831 Power Building
TENNESSEE VALLEY AUTHORITY
CHATTANOOGA, TENNESSEE 37401

January 27, 1976

Enclosed for your review are ten copies of our responses to a request for additional information concerning the Borated Water Storage Tank, which resulted from your review of Amendment 13 to the Bellefonte Nuclear Plant PSAR. These responses were discussed with your staff during telephone conversations held on December 9, 1975, and January 6, 1976.

Figure 1.1

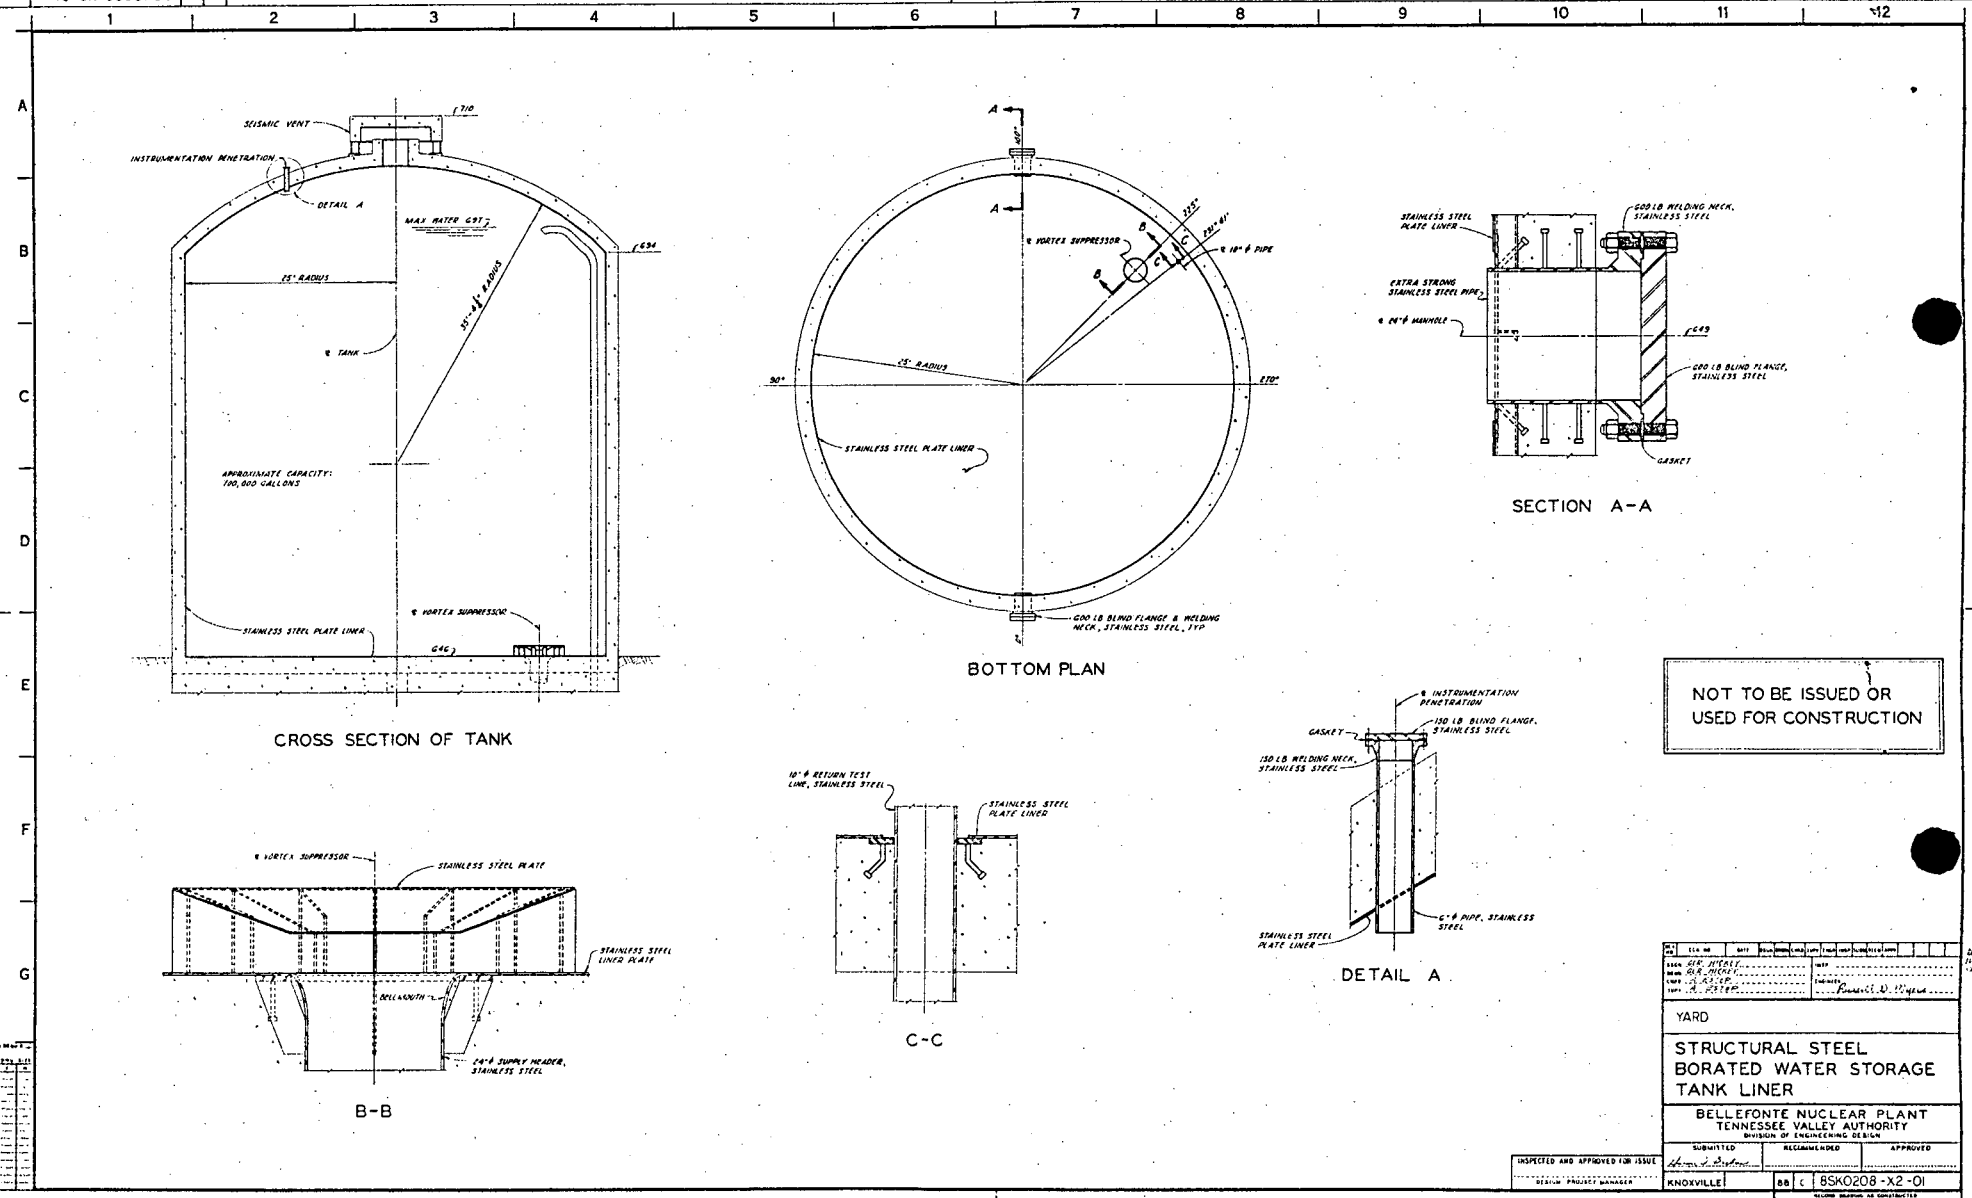
1. You have indicated that the new design of the borated water storage tank will be in accordance with ACI 318-71. However, this code is only applicable to the reinforced concrete portions of the tank. Describe the design and analysis procedures and structural acceptance criteria utilized in the design of the stainless steel liner. (MTEB is reviewing the materials, fabrication, and inspection procedures for the tank liner.)
- (3.8.4.4.6) The applicant is requested to identify for the stainless steel liner; (1) the code or standard to be applied for fabrication, (2) the non-destructive examination to be performed, and (3) the grade and specification of the material(s) of construction.

The liner is to be of stainless steel with a system of carbon steel angles, channels, or concrete studs as required to maintain stability of the liner during construction. The sole purpose of the liner is to provide a watertight membrane. The liner shall be designed for temperature stresses and working stresses in accordance with the requirements of the AISI "Specification for the Design of Cold-Formed Stainless Steel Structural Members," 1974 edition.

The stainless steel liners shall be fabricated in accordance with the TVA drawings and specification and shall conform with applicable portions of the AWS Structural Welding Code D1.1-75. Joint welding procedures to be used in fabrication of the stainless steel liner will be qualified, in accordance with ASME Boiler and Pressure Vessel Code, Section IX, prior to use by TVA or the fabricator.

There will be 100-percent dye penetrant examinations of all welds exposed to the contents of the lined vessel using properly qualified or experienced personnel and in accordance with the ASME Boiler and Pressure Vessel Code, Section III, Subsection NC, latest edition.

The stainless steel liner shall be SA-240 or ASTM A167, Type 304. Stiffener bars or shapes on the outside of the liner shall be ASTM A36.

The PSAR lists the BWST as a category I structure. Therefore TVA drawings and specifications will require certified material test reports and complete traceability on all stainless steel liner plates; all other material attached to the liner will require certification that it conforms to the appropriate ASTM specification.

Figure 1.1 shows penetrations through the BWST.

Figure 2.1

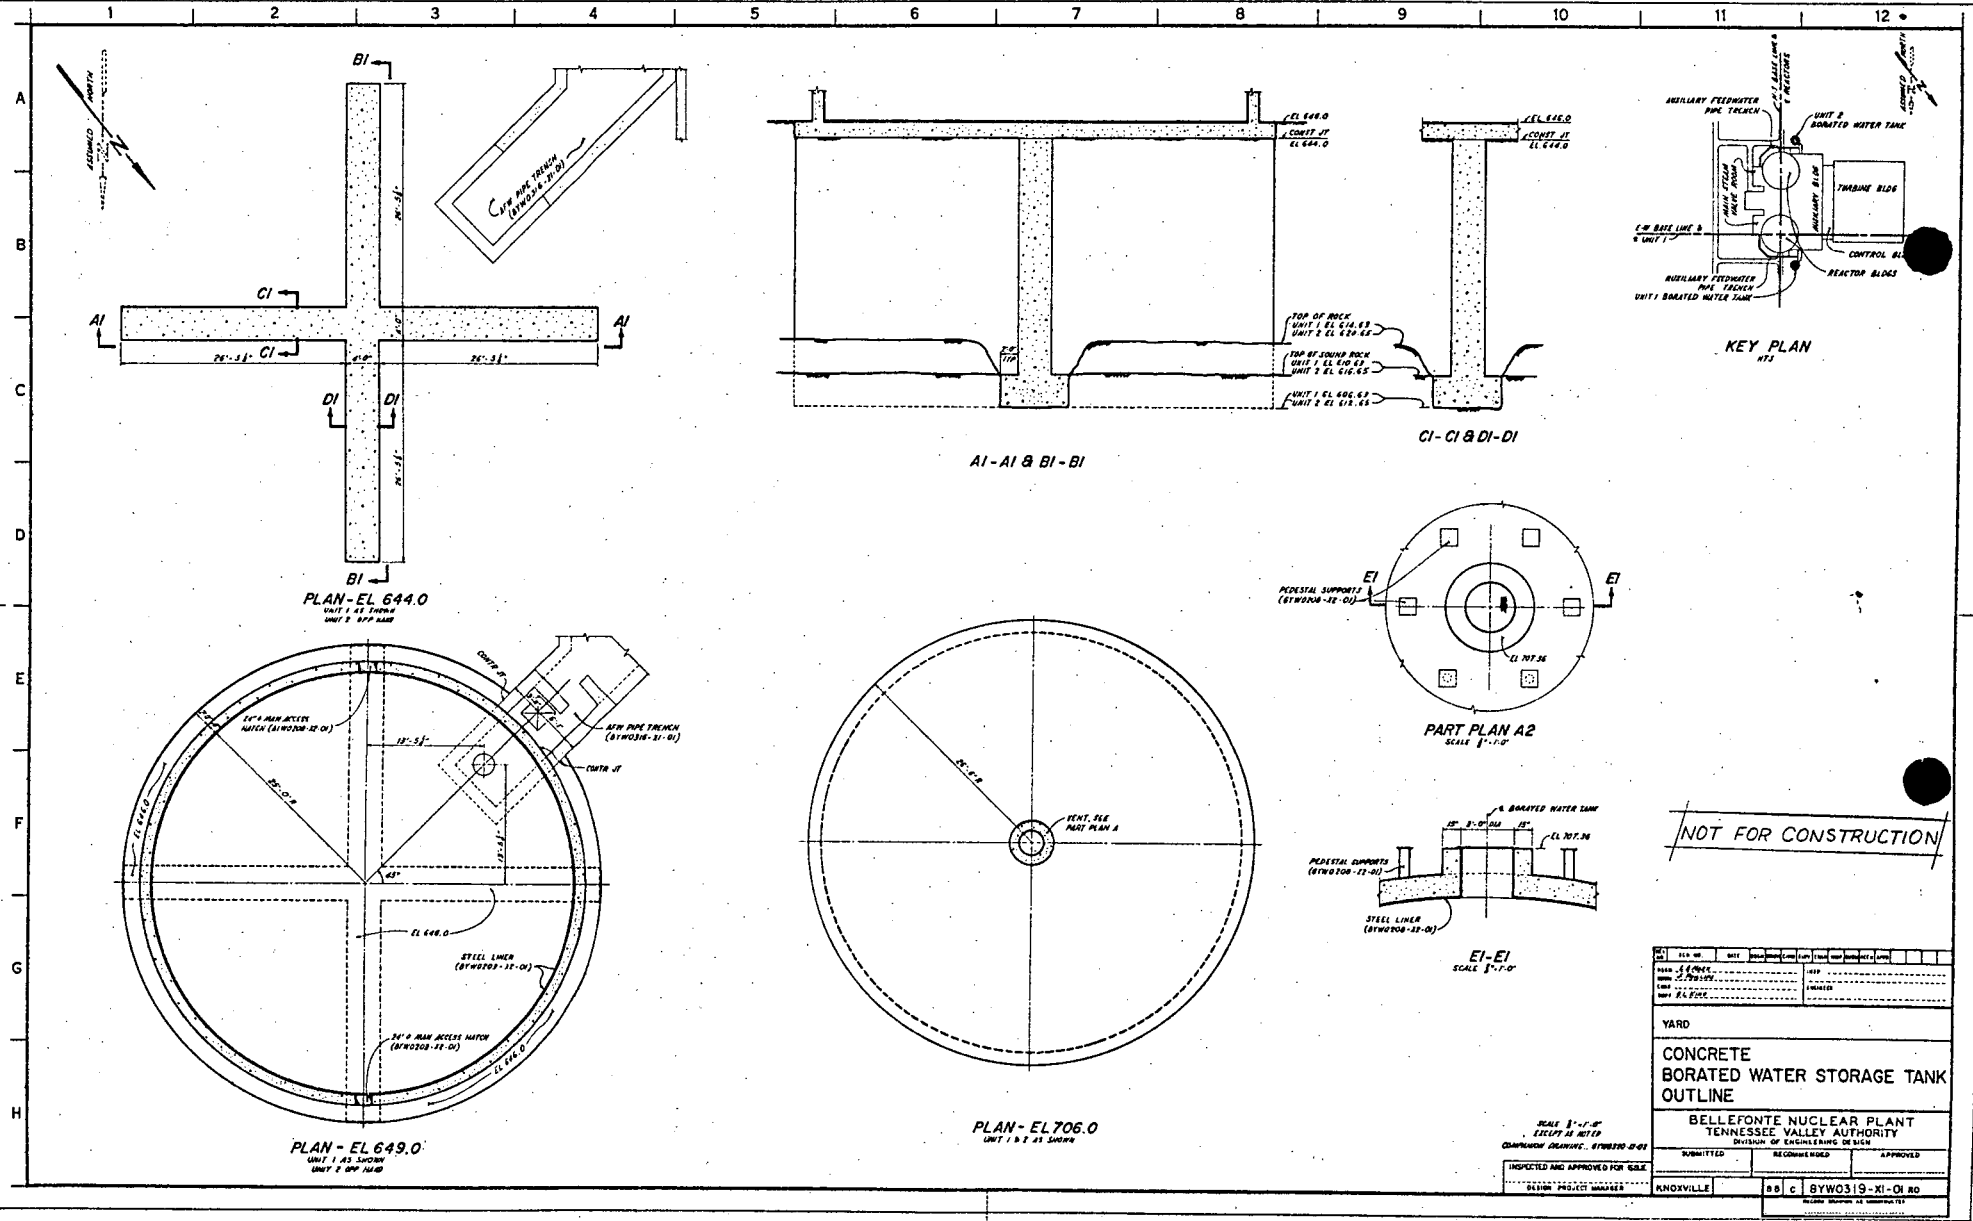
2. You have indicated that the BWST will now be supported on a reinforced concrete pedestal foundation founded on rock. However, the design of this foundation is not clear. Provide the following information
- (a) Fig. 3.8-40c shows only an elevation of the tank foundation. Provide a horizontal section through the foundation to permit a better understanding of the foundation plan.
 - (b) Provide the factor of safety against sliding and overturning for each applicable load combination.
 - (c) Provide the permissible bearing and shear stresses at the concrete rock interface used in computing the factors of safety in (b) above and discuss the bases of these values.

- (a) Figure 2.1 shows the latest dimensions and configurations of the foundation for the borated water storage tank. Note the footings will be keyed into sound rock to a depth of 4 feet.
- (b) The minimum factors of safety against sliding, overturning, and floatation will be shown for the following load combinations.

- (c) The results of TVA's testing program on foundation rock samples showed the rock compressive strength is greater than the concrete compressive strength. Therefore, the permissible bearing stress at the concrete rock interface is limited to the concrete stress

allowable of ACI 318-71. Note: A detailed investigation of all loading conditions revealed a maximum calculated bearing stress less than 700 psi.

For purposes of resisting horizontal forces, no bond is assumed along the plane of contact between concrete and rock or at bedding planes or fault zones in rock. Frictional forces along the plane of contact between concrete and rock are not assumed to exceed 70 percent of the normal force of the plane. The horizontal forces are resisted by the normal forces multiplied by the coefficient of friction between the concrete footing and the rock. The normal force includes the effects of the vertical acceleration of the structure for seismic load combinations. However, the normal force also includes a soil wedge weight acting on the 2-foot flange extension each side of the footings. This wedge will be formed with an angle of $(45 \text{ degrees} - \phi/2)$ off the vertical where ϕ is the angle of internal friction of the soil.

Figure 3.1

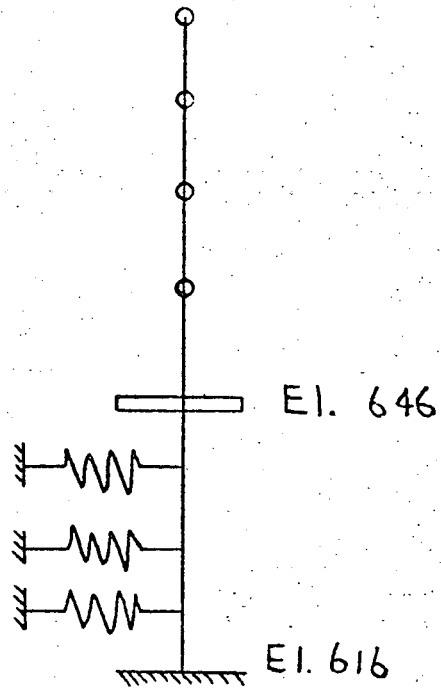
3. Since you consider the BWST to be completely supported on rock, you have deleted all procedures in Section 3.7 which refer to soil structure interaction. However, your proposed pedestal foundation, although founded on rock, will be embedded in 30 feet of soil. Thus, the embedded depth exceeds 15 percent of the least base width (50 foot diameter) and the foundation should be considered deeply embedded as indicated in SRP Table 3.7.2-1. Clarify how the concrete pedestal foundation, its surrounding soil, and the retaining structure adjacent to the pedestal are modeled in the dynamic analysis of the structure. Discuss the bases for all assumptions which are made.

The proposed configuration of the borated water storage tank and foundation is shown in figure 2.1. As shown in this figure, the tank is supported by two concrete walls intersecting at right angles and embedded in approximately 30 feet of soil and 4 feet of rock. The seismic analysis of this system was performed using two independent methods. The first model, figure 3.1, used beam elements to represent the foundation and tank with lateral springs representing the influence of the soil. The lateral springs were evaluated using reference 1. It is recognized that this representation of the soil is an approximation but it is felt a reasonable one since the soil is not expected to be a significant factor in the response of this rock-founded structure.

The site design response spectra is defined at top of rock. For ease of comparison with the finite element analysis, a time history analysis was performed with this model using the enveloping acceleration time history as input. Damping values of 4 percent and 7 percent were used for the operating basis earthquake and the safe shutdown earthquake.
